**PRELIMINARY DRAINAGE REPORT AND MDDP ADDENDUM
FOR
HOMESTEAD NORTH AT STERLING RANCH PRELIMINARY PLAN**

**October, 2021
Project No. 25188.00**

**PCD Filing No.:
SP-20-008**

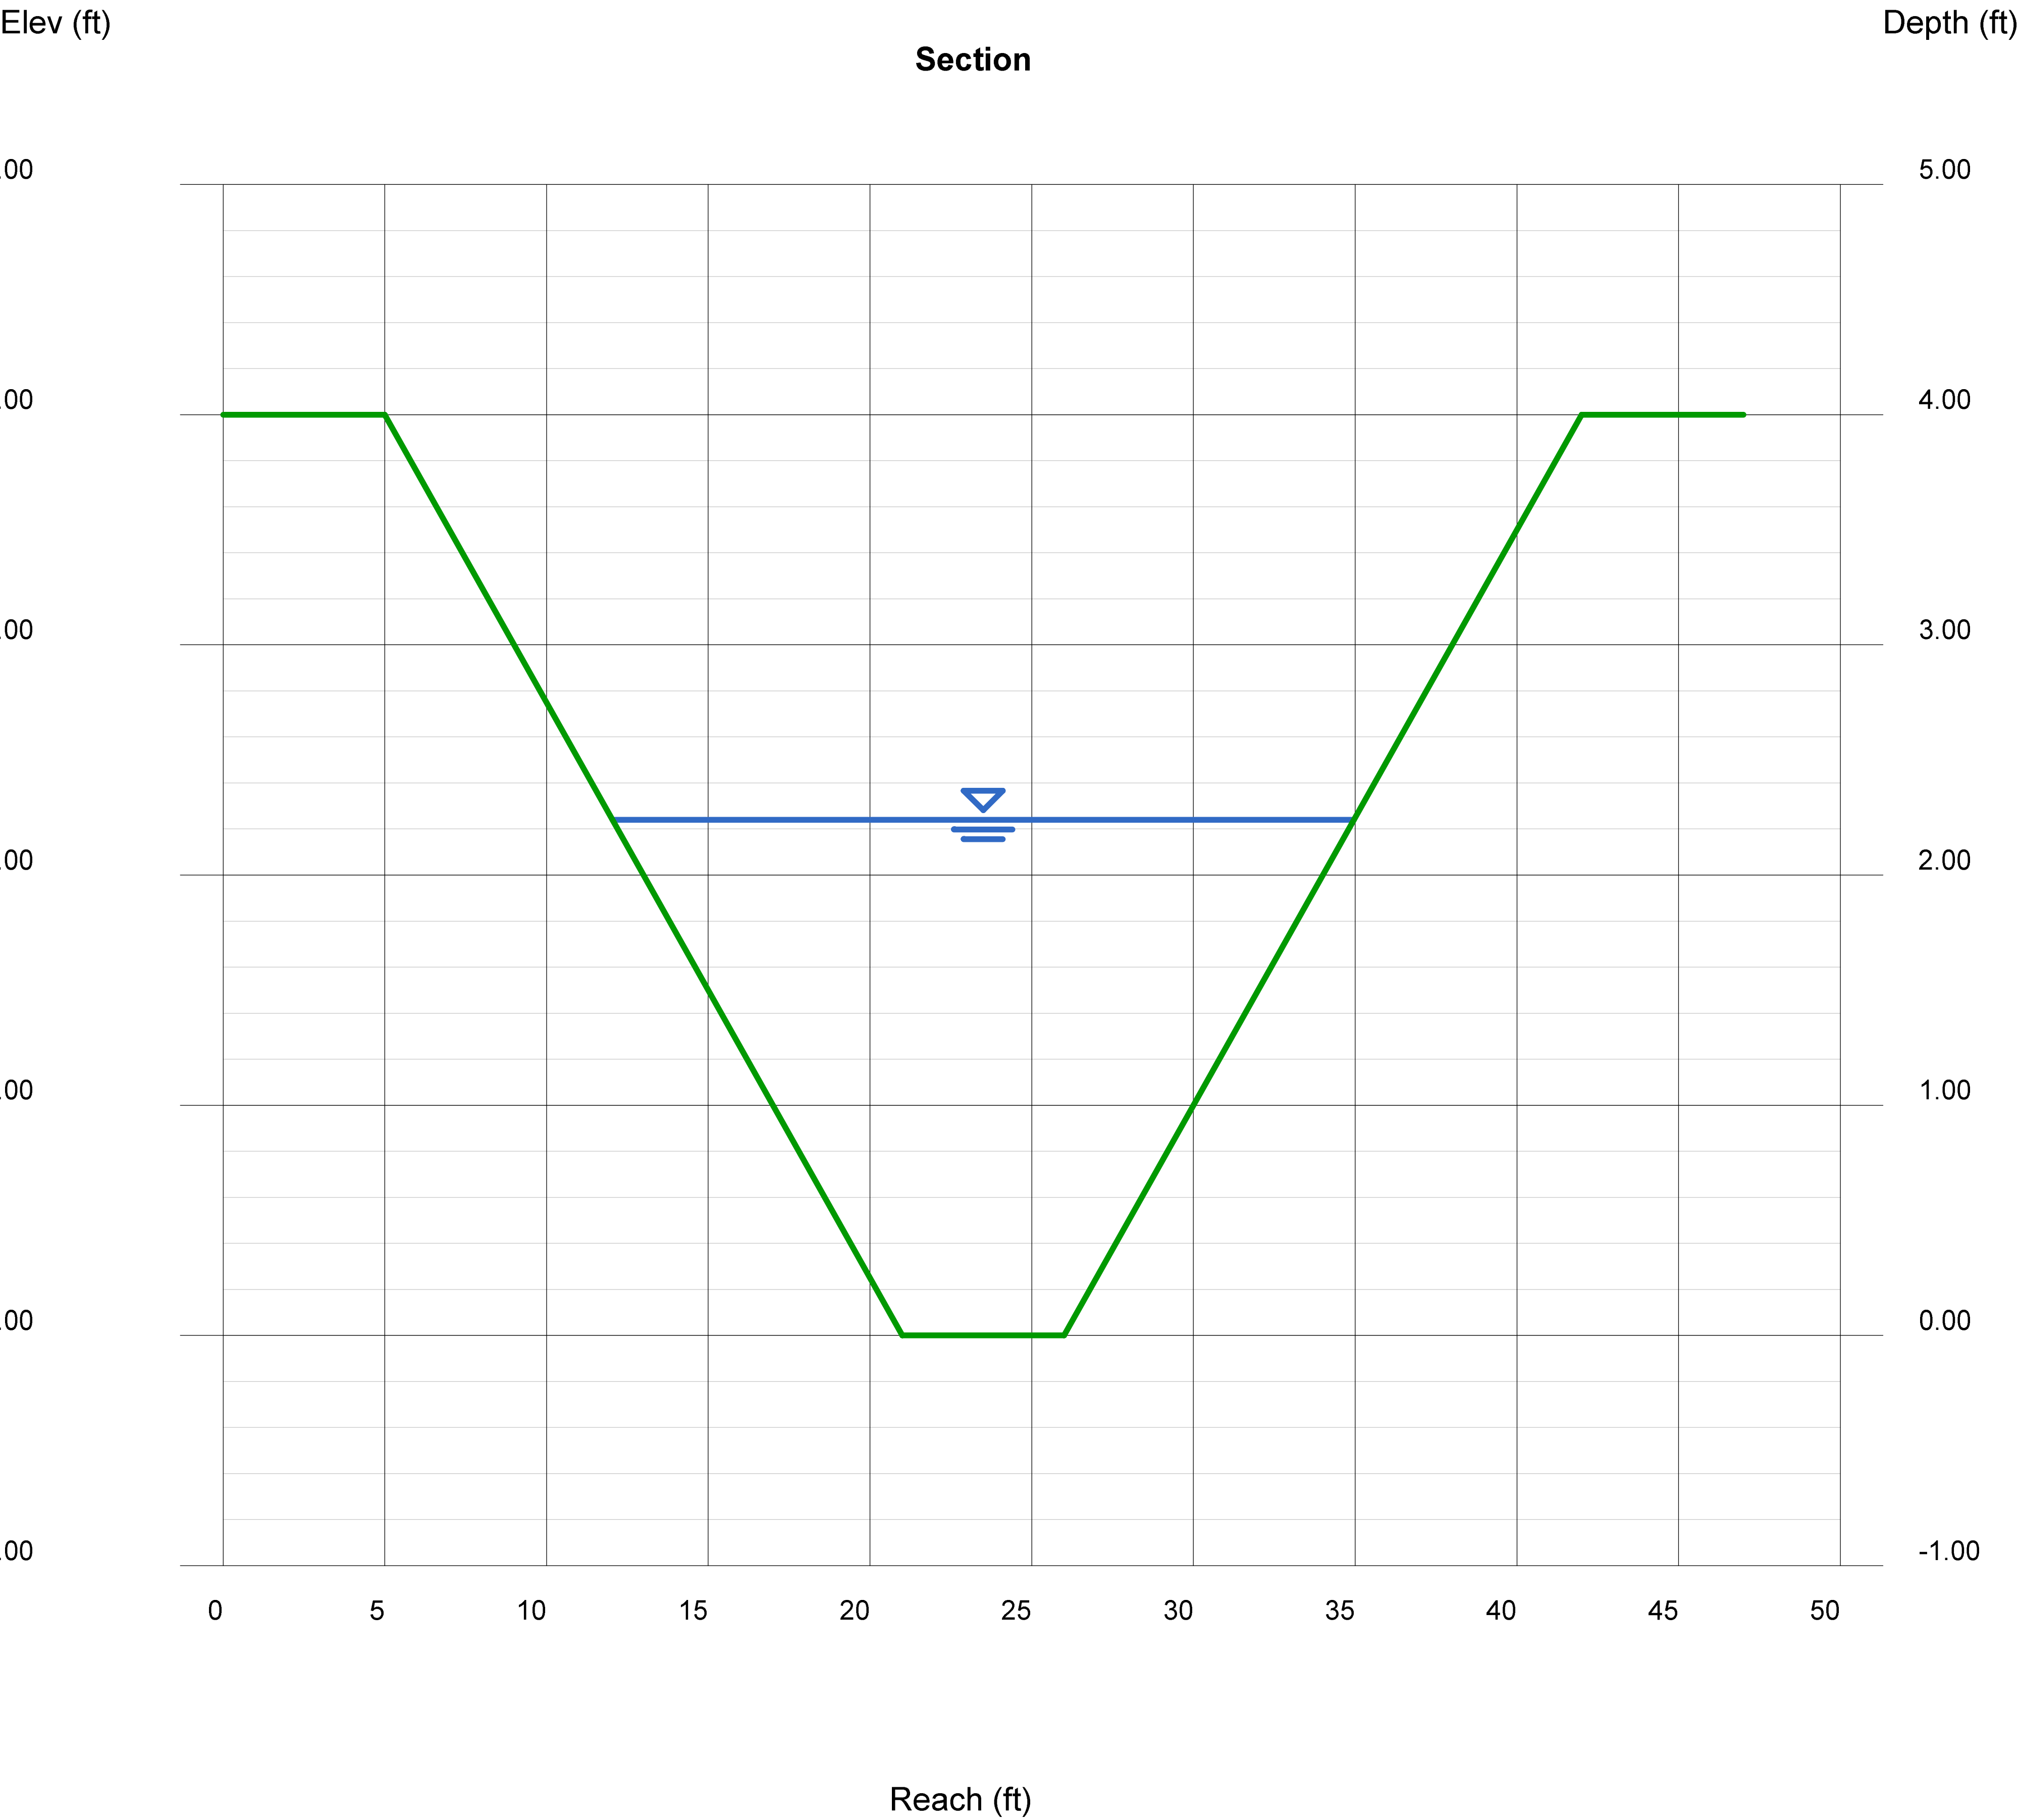
Highlighted

JR Response: label added
"USE PERMANENT
EROSION CONTROL
BLANKET
V MAX SC250
OR EQUIVALENT"

EARLY GRADING - DRAINAGE MAP
HOMESTEAD NORTH
JOB NO. 25188.00
09/16/21
SHEET 4 OF 4

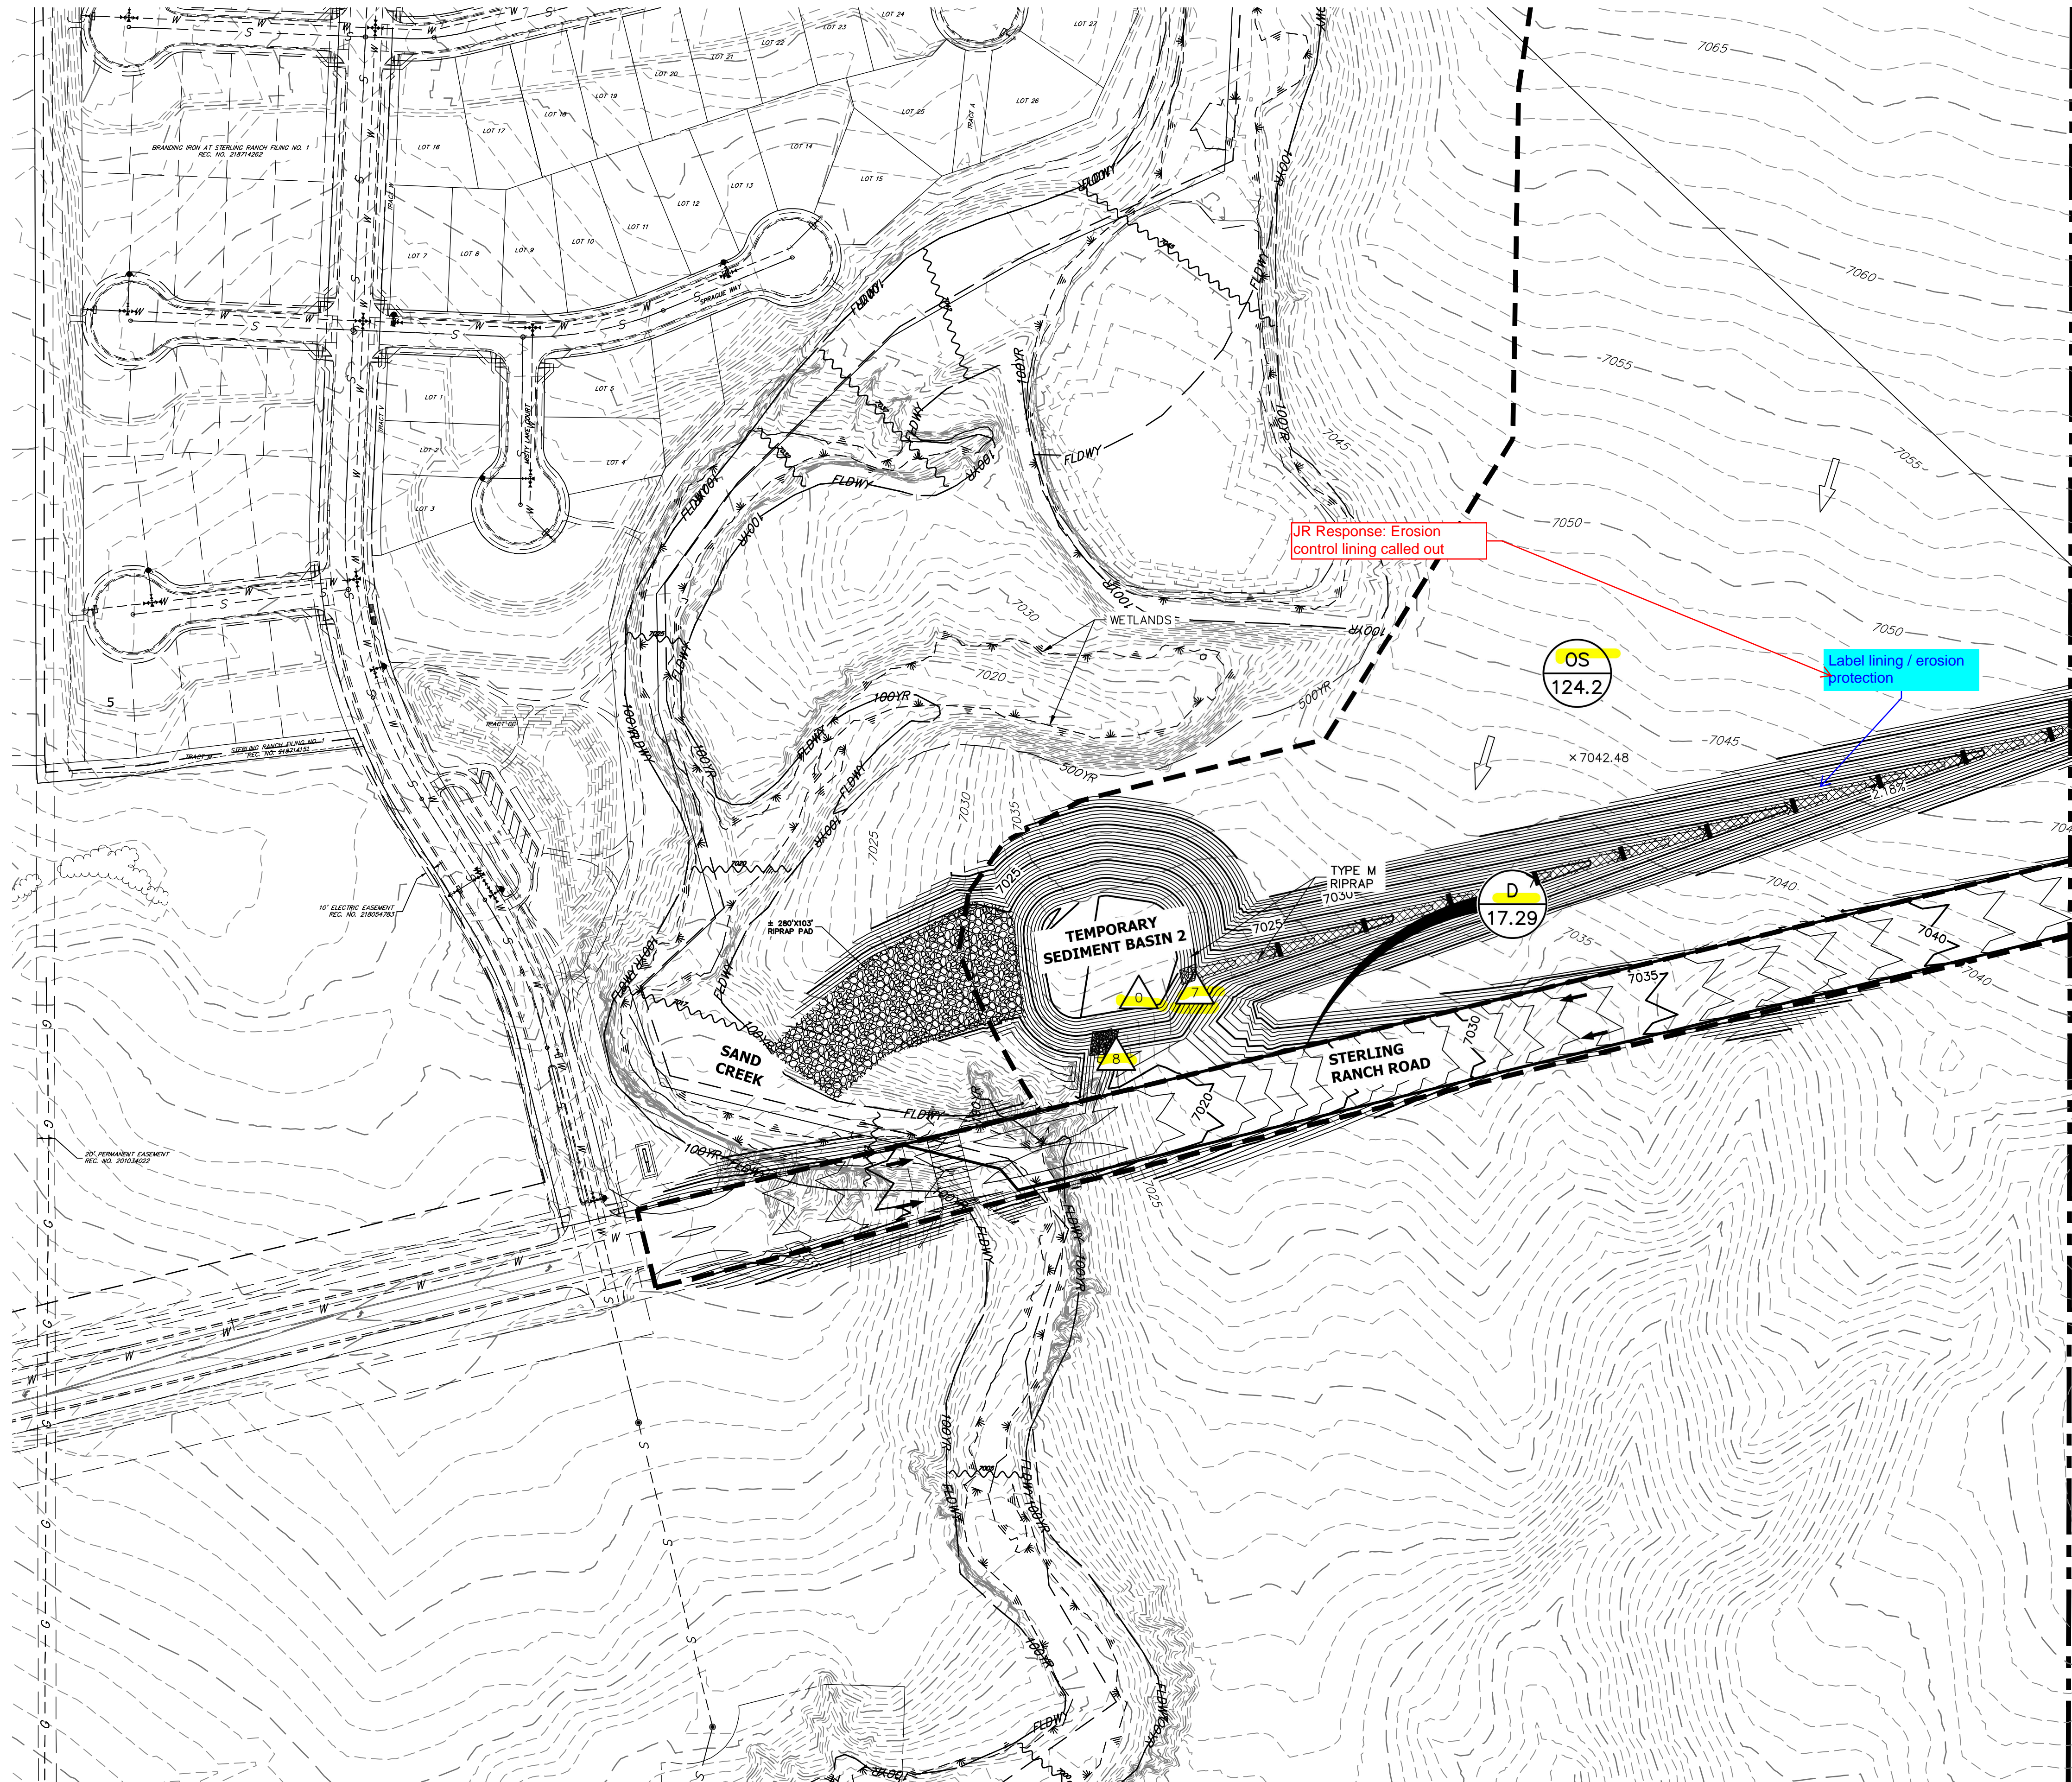
Verify size based on contributing area from east side of SRR

DRAINAGE MAP
HOMESTEAD NORTH
JOB NO. 25188.00
10/08/21
SHEET 2 OF 2

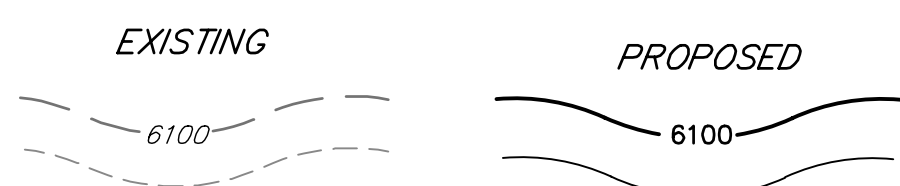
Missing DP's 11b, 12b, 4.2c, 3.1c, 6c & 1.7d on Drainage Plan
